Product hierarchy no. *				Part no.	SBU	Type / Description	Customer part no.
SBU	PG	PUG	Type				
80	084	002	0000006146	See list below	EMC	FMLB-09

2 Type of change

Product Change Notification					PCN FMLB-09 case 73 redesign		
owner	creation date	release date	released by	change order no	rev	page	D10-047-007
segatro	03.07.2020	10.07.2020	blumhe	2020132	A	1 of 2

Old product appearance	New product appearance

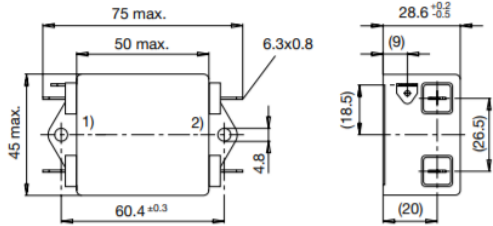
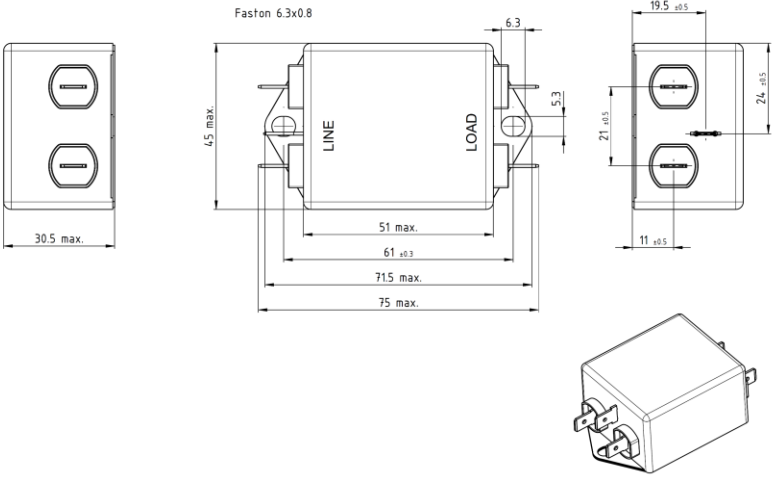
- Nickel plated steel case instead of aluminium case
- Different shape and position of external quick connect terminals
- Different position of earth terminal
- Different fixing center distance

- Change of product appearance due to new nickel-plated steel case instead of aluminium case
- New case is provided with a bottom cover
- Moved position and different shape of plastic part for external quick connector terminals
- Moved position of earth terminal
- New elongated mounting hole with different distance 60.4 ±0.3 to 61 ±0.3 fits old mounting dimensions
